CITY OF SANTA BARBARA

COUNCIL AGENDA REPORT

SUBJECT: Contract For Final Design Of The Mason Street Bridge Replacement Project

HISTORIC LANDMARK COMMISSION CASE SUMMARY

BRIDGE DESIGN EXCEPTION MATRIX

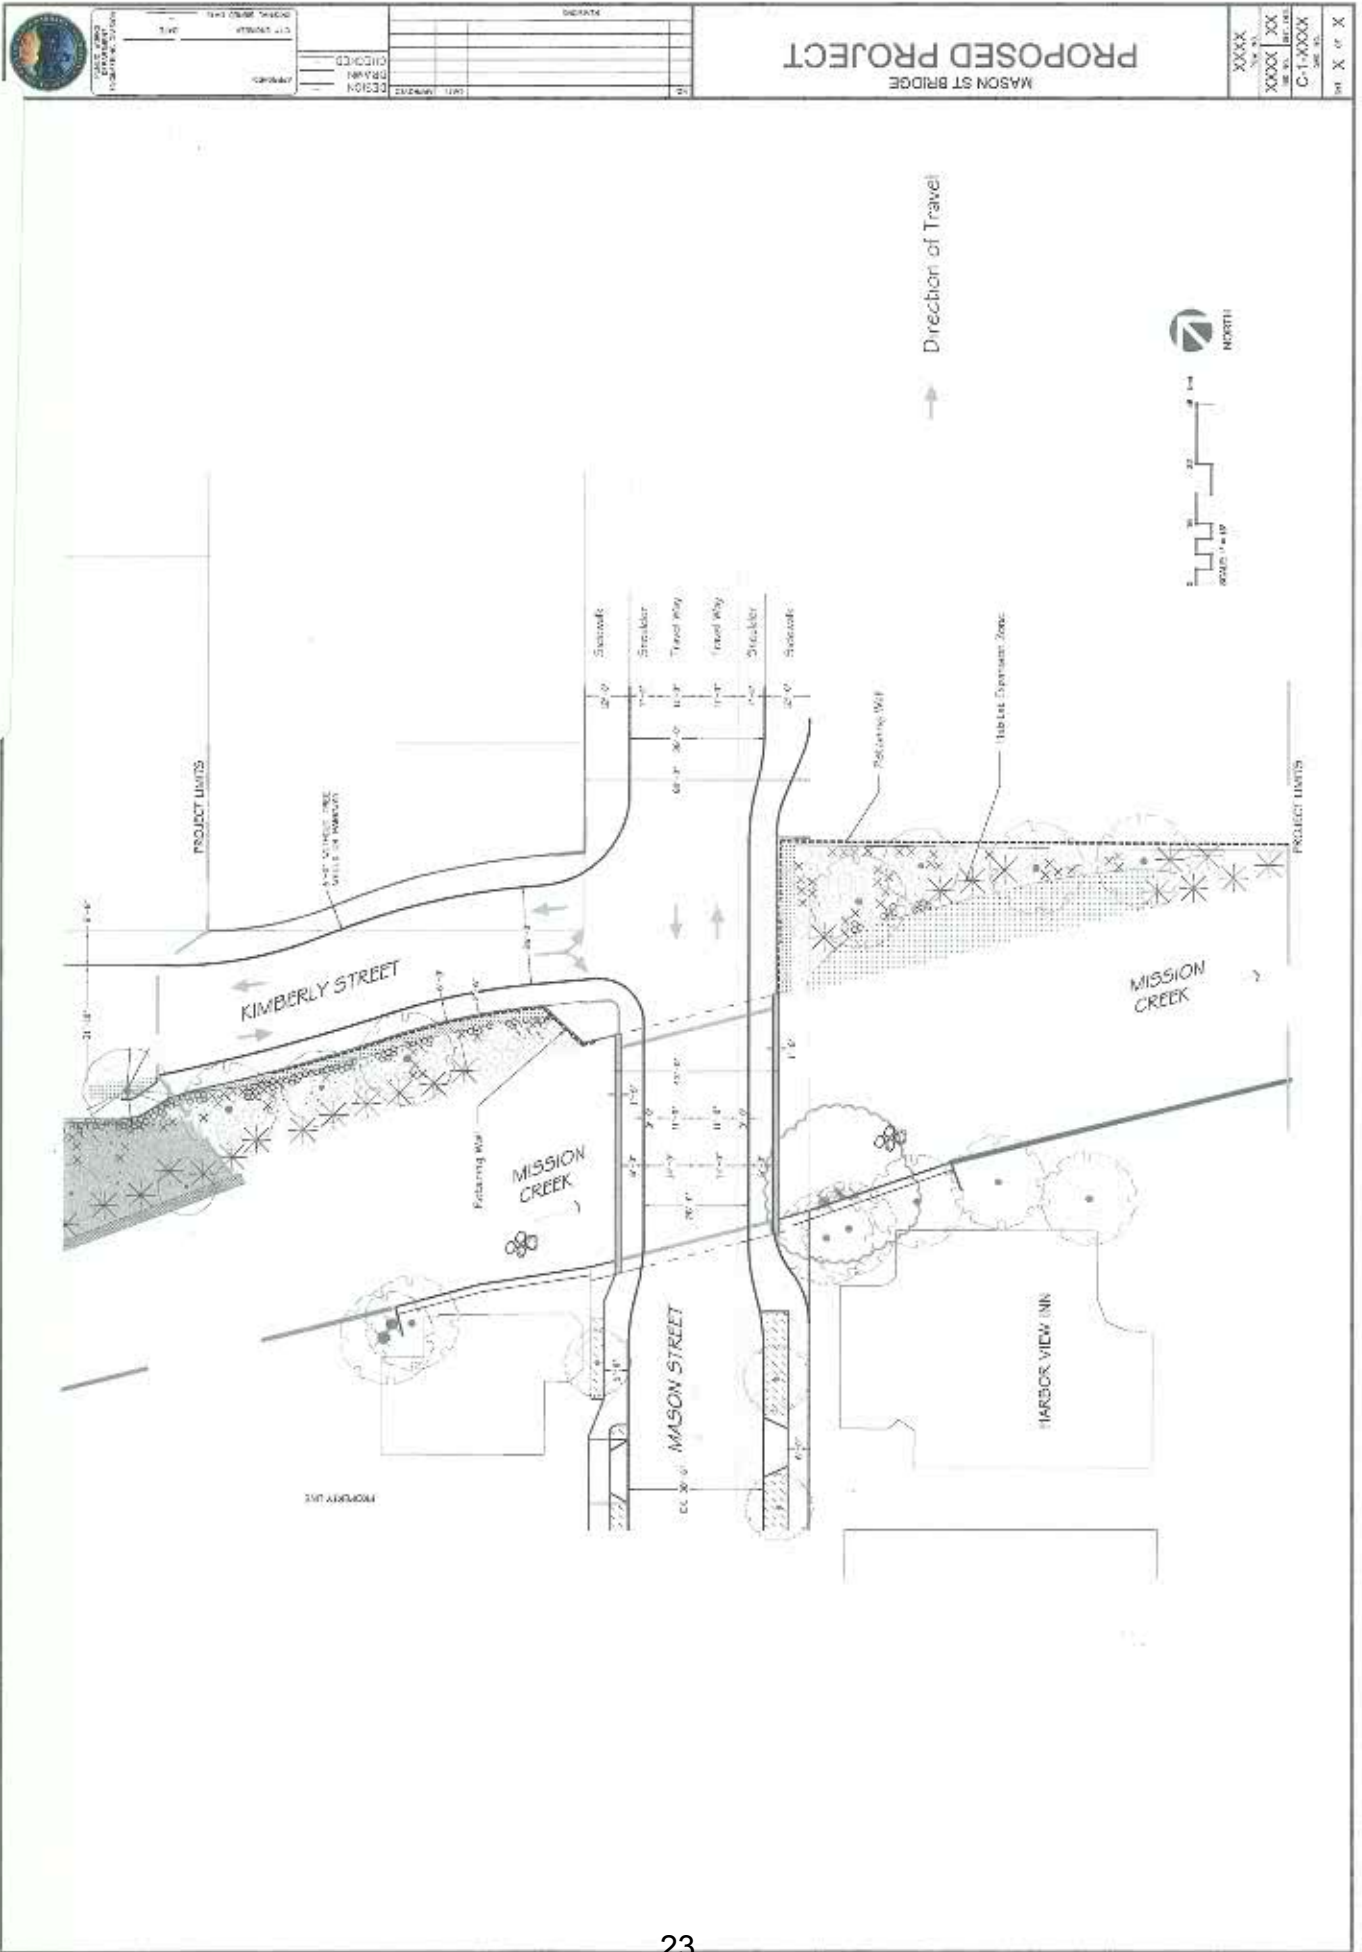
Bridge Roadway Width	Design Criteria				Comments	Item(s) Requiring Design Exception ²
	[1] 30' Minimum Roadway Width Met per AASHTO and Caltrans?	[2] 12' Traveled Way Width Met per Caltrans?	[3] Kimberly Avenue Sight Distance Met per AASHTO?	[4] Bridge Roadway Width Equals Roadway Approach Width per AASHTO and Caltrans?		
28'	No	No	Yes if "See-Through Bridge Rail" is feasible	No	Proposed bridge roadway width < 30' minimum required roadway width to meet AASHTO standards. 11' TW < 12' minimum TW. Bridge roadway width < 36' roadway approach width at EO. Bridge roadway width < 38.5' roadway approach width at WO.	[1], [2], [4]
30'	Yes	No	Yes if "See-Through Bridge Rail" is feasible	No	11' TW < 12' minimum TW. Bridge roadway width < 36' roadway approach width at EO. Bridge roadway width < 38.5' roadway approach width at WO.	[2], [4]
32'	Yes	No	Yes	No	11' TW < 12' minimum TW. North bridge rail must be located 26.5' from Mason St. centerline for sight distance. Bridge roadway width < 36' roadway approach width at EO. Bridge roadway width < 38.5' roadway approach width at WO.	[2], [4]

SIGHT DISTANCE CRITERIA COMPARISON CHART

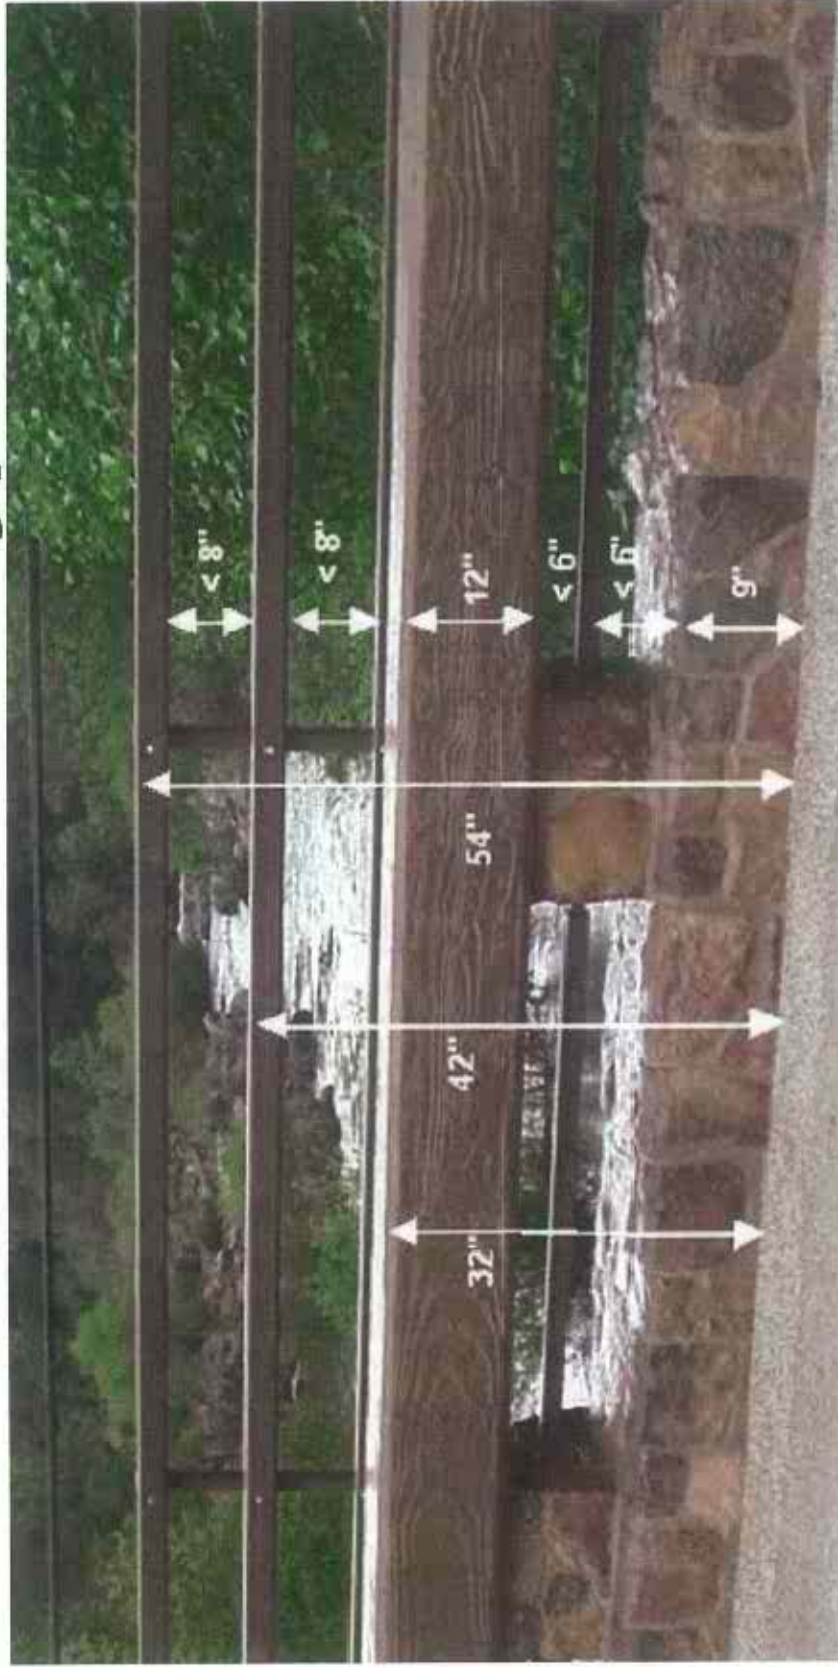
Proposed Geometry:	Kimberly Avenue- 2-WAY TRAFFIC with Sight Distance Criteria	Kimberly Avenue- 1-WAY TRAFFIC (NB from Mason Street) without Sight Distance Criteria	Kimberly Avenue- 2-WAY TRAFFIC (NB from Mason Street) with Sight Distance Criteria and using See-Through Bridge Rail
[1] Traveled Way Width (WB/EB)	32' Mason Street Bridge 11'11" *	28' Mason Street Bridge 11'11" *	28' Mason Street Bridge 11'11" *
[2] Shoulder Width (WB/EB)	7'3"	3'3"	3'3"
[3] Bridge Roadway Width ([1]+[2])	32'	28' *	28' *
[4] Sidewalk Width (NS/SS)	8.5'6"	8'6"	8'6"
[5] Barrier Rail Width (NS/SS)	1.5'1.5'	1.5'1.5'	1.5'1.5'
[6] Total Bridge Width	48.5'	43'	43'
